No. **24-266, CD1**

RESOLUTION

GRANTING A SPECIAL MANAGEMENT AREA MAJOR PERMIT TO ALLOW FOR THE CONSTRUCTION OF A NEW SINGLE-FAMILY DWELLING WITH A GARAGE, A SWIMMING POOL, AND OTHER IMPROVEMENTS IN MĀ'ILI, O'AHU.

EXHIBIT C-1 - SITE PLAN WITH SHORELINE SETBACK AND COASTAL EROSION PROJECTIONS
FILE NO. 2024/SMA-75

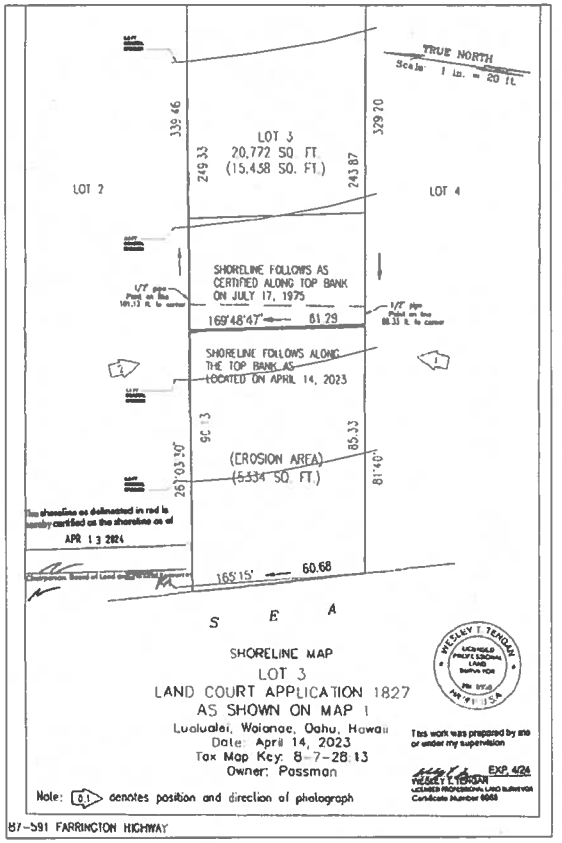
a. All structures must be relocated mauka of the 2.0-foot Sea Level Rise Exposure Area ("SLR-XA") coastal erosion line as mapped on the Hawai'i Sea Level Rise Viewer (see Exhibits C-1, C-2, and H);
